ADDENDUM #2

Project Name:
Newton Correctional IPI Homes for Iowa Phase II
A/E Project # 02401959.001
DAS# 9239.02 & 9239.03
RFB 923902-01
Addendum #2
Dated: August 20, 2025

Addendum Number: 002

Project Name: Newton CF IPI Homes for Iowa Phase II

8/20/2025 12:25:10 PM L:\LAND PROJECTS\2023\0091-1 NEWTON CORRECTIONS DRIVE IMPROVEMENTS\DWG\C6.1 DETAILS.DWG
L:\Land Projects\2023\0091-1 Newton Corrections Drive Improvements\dwg\C6.1 DETAILS.dwg 8/20/2025 10:10 AM

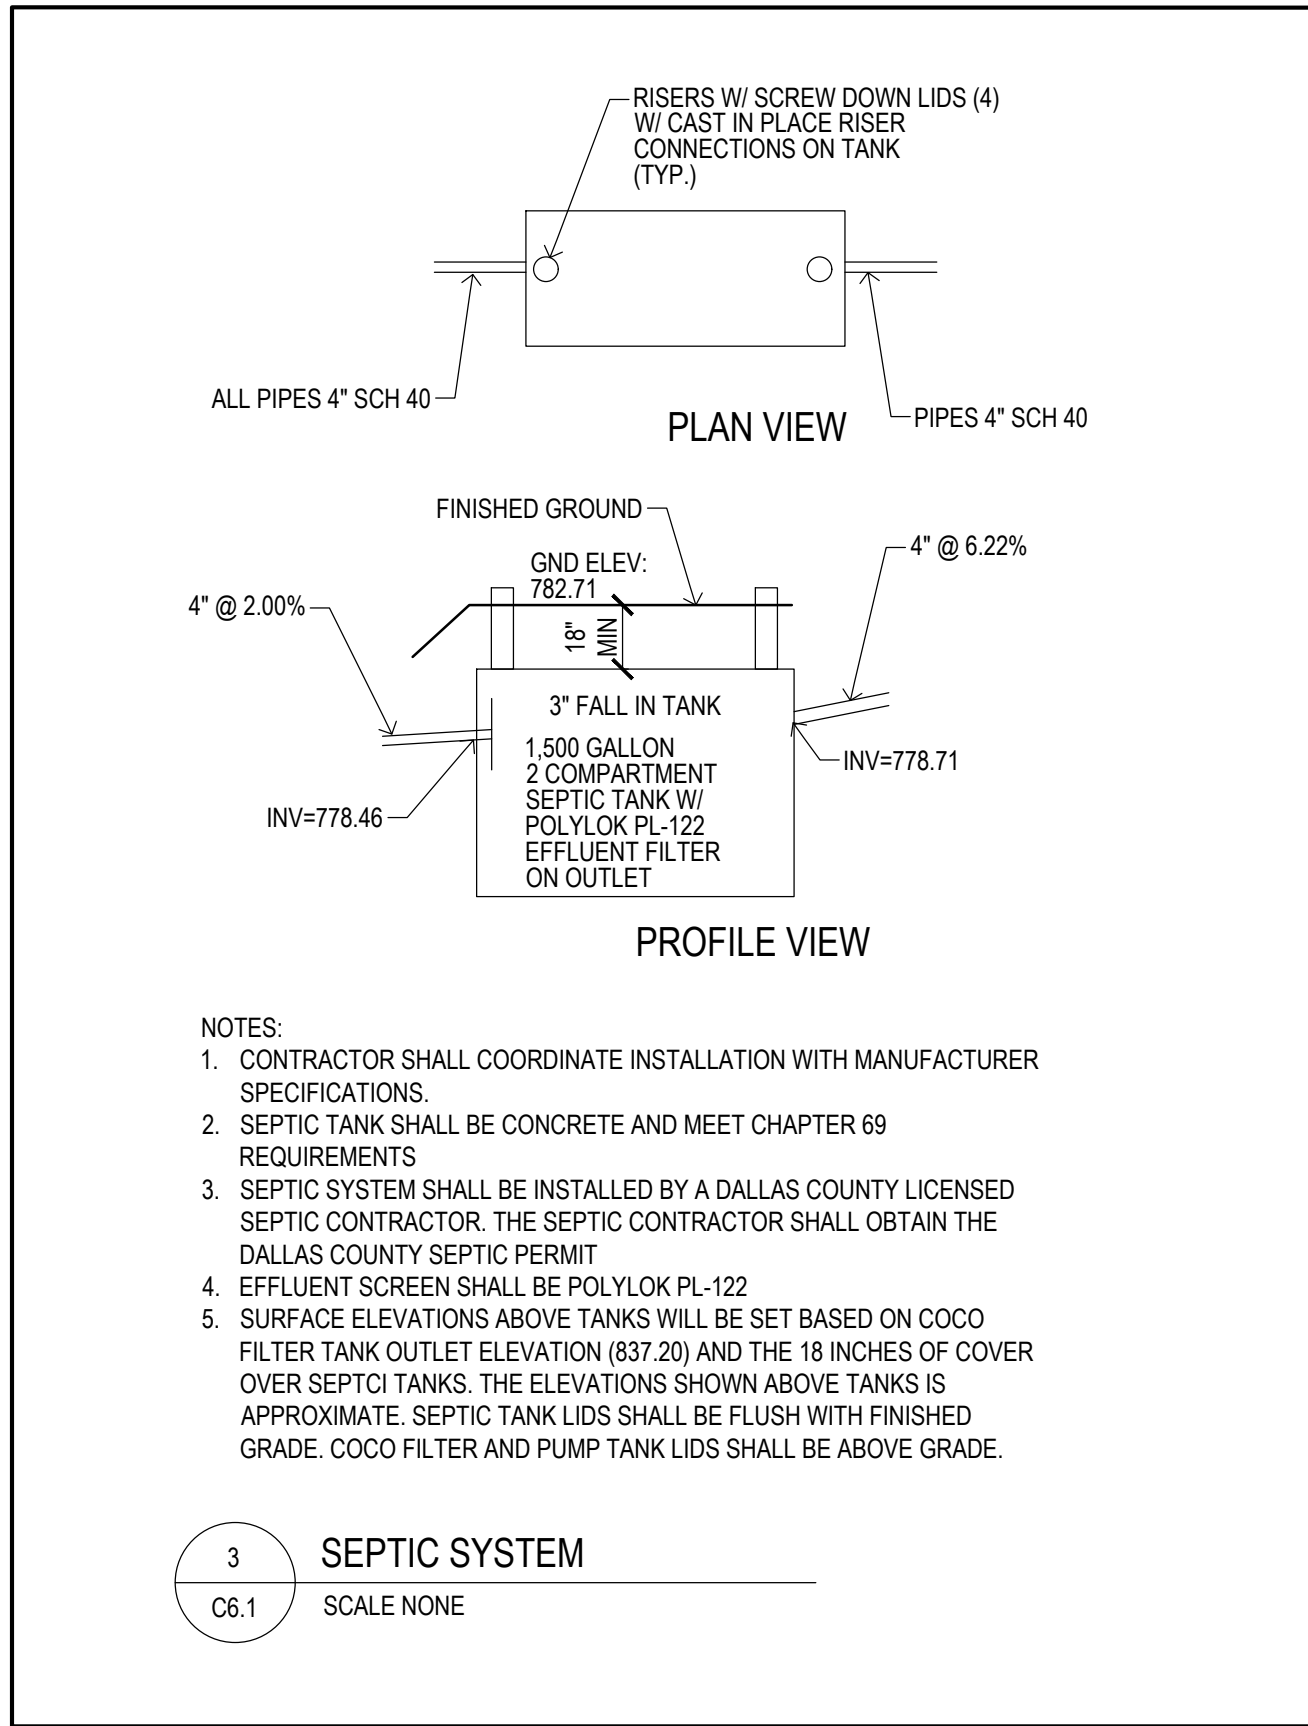
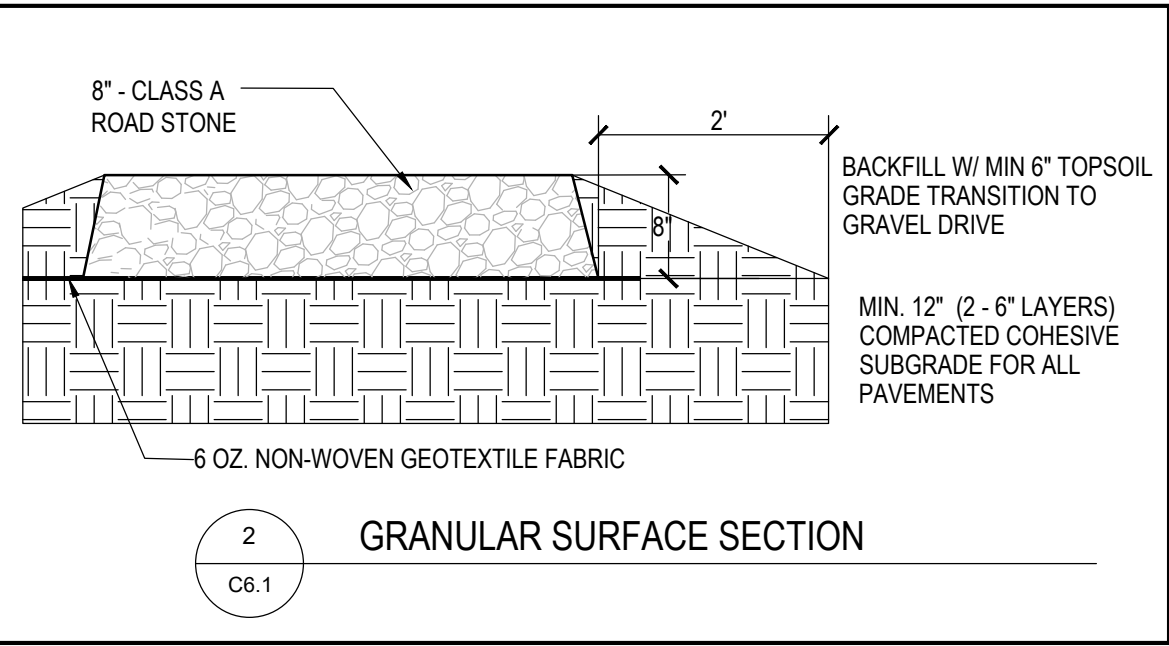
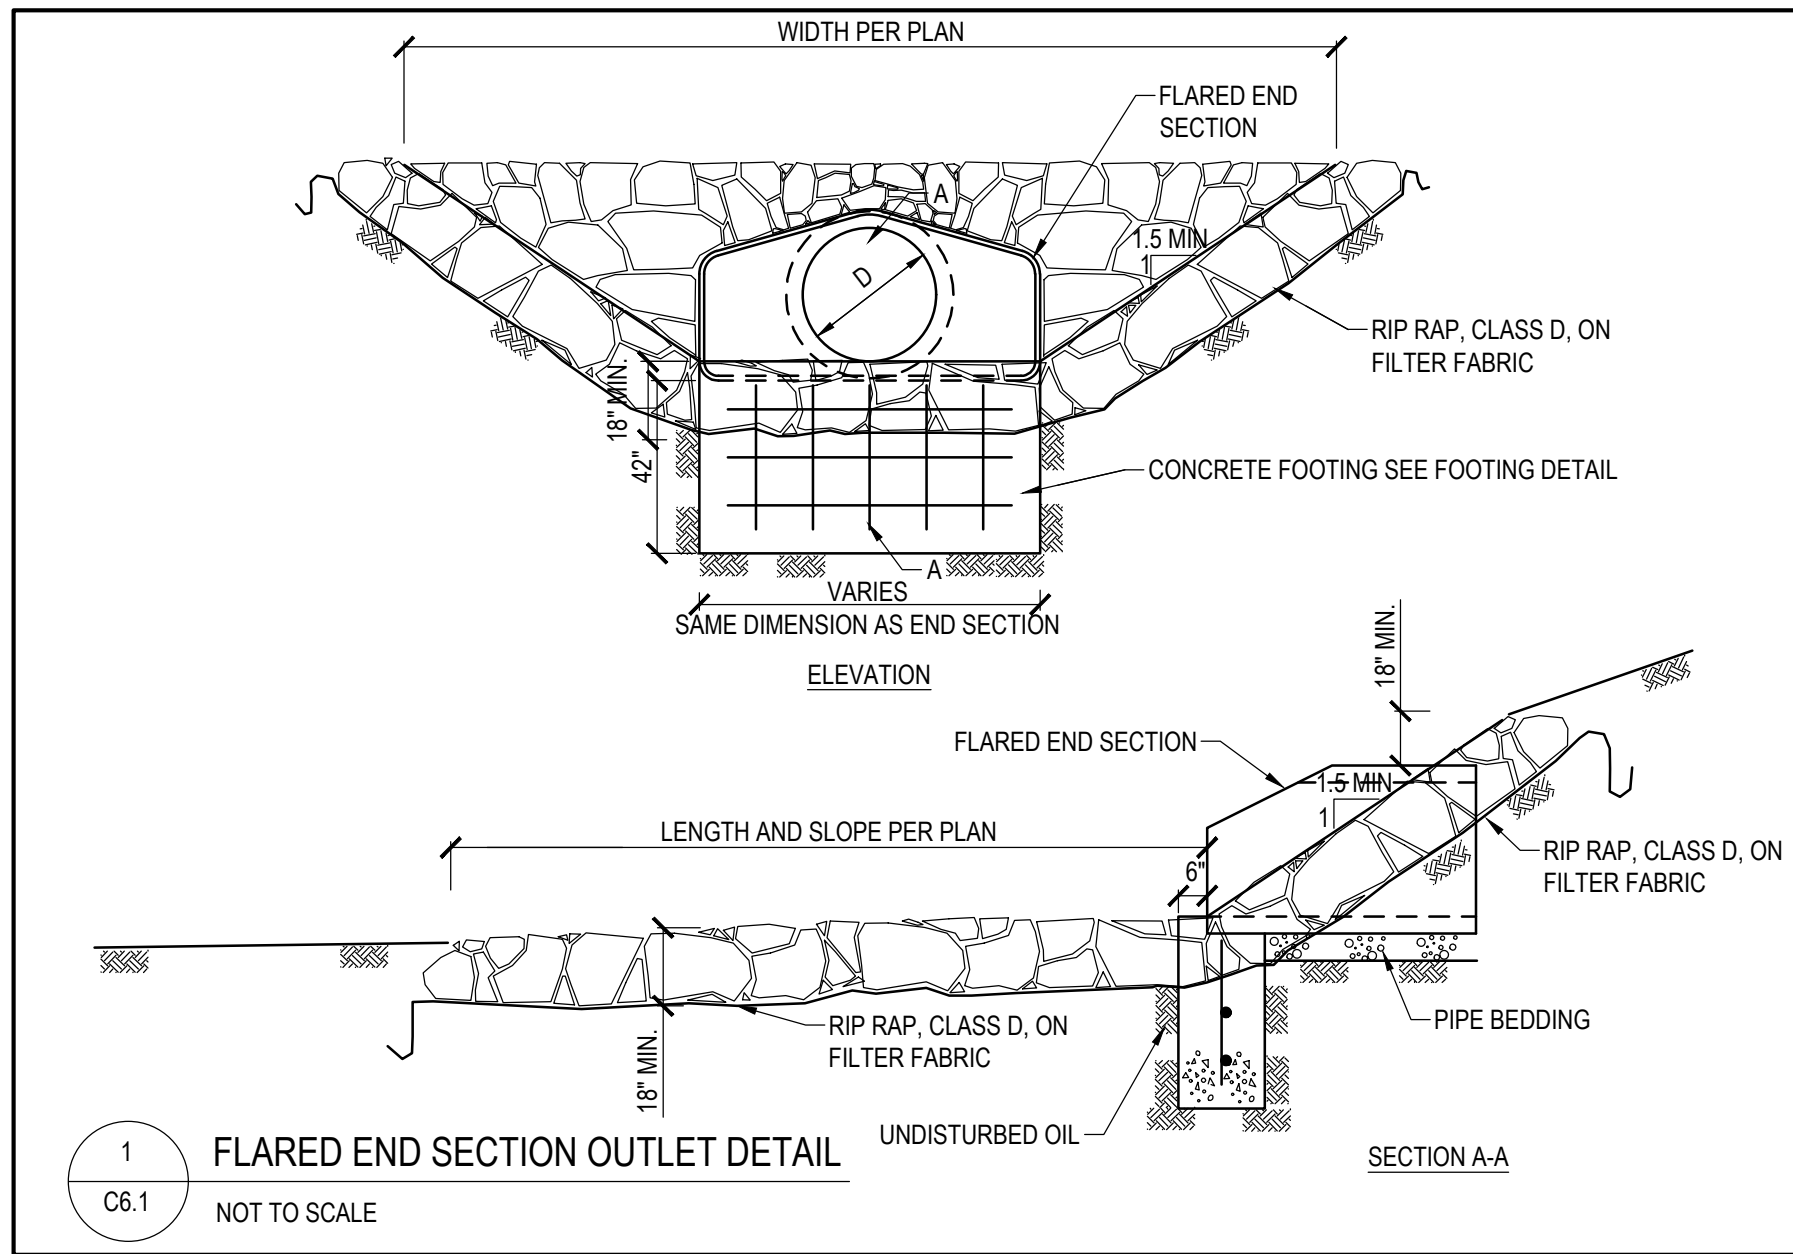
- Item No. 19 Added Detail for SW-303 Manhole to be placed over existing 8" Sanitary Line for new Connection.

FLOOR PLAN - SHEET
METAL

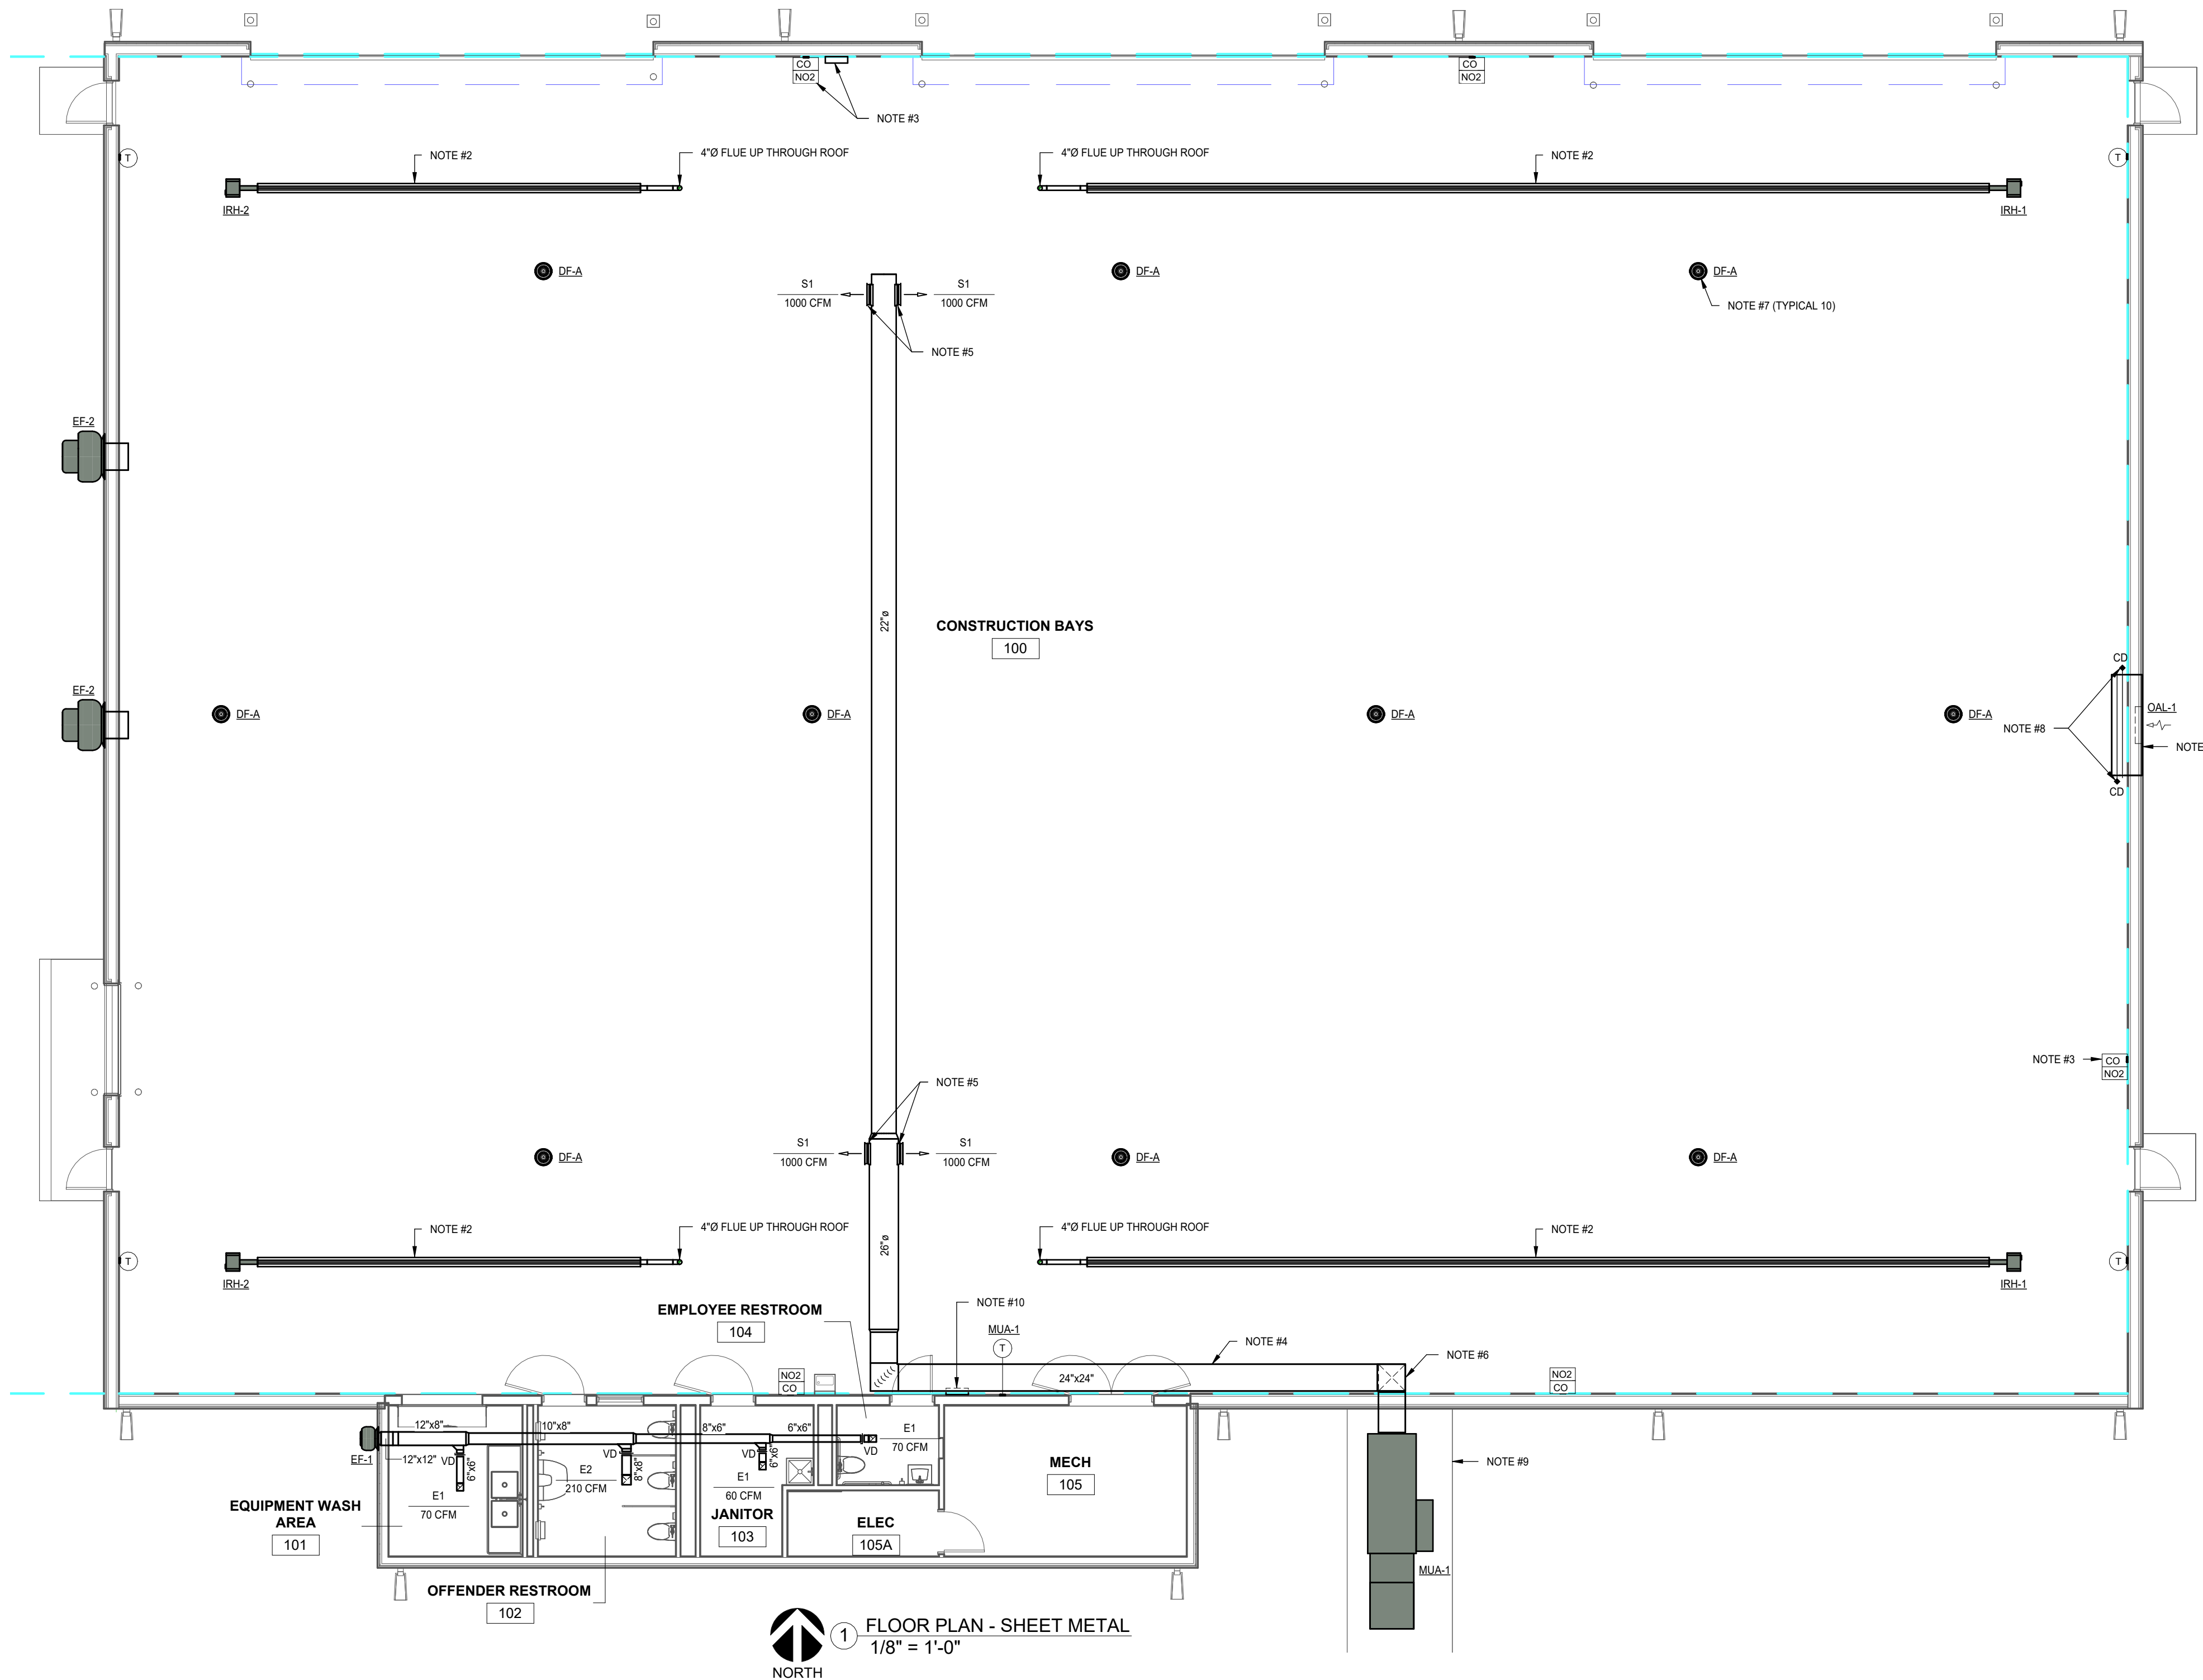
Revise Note #9.

Concrete mounting pad for mounting MUA-1 to be provided as part of Bid Package #1 General Construction. Selected MUA-1 manufacturer to provide necessary pad dimensions, specifications, etc. for the selected unit. Reference S1.1 for further details.
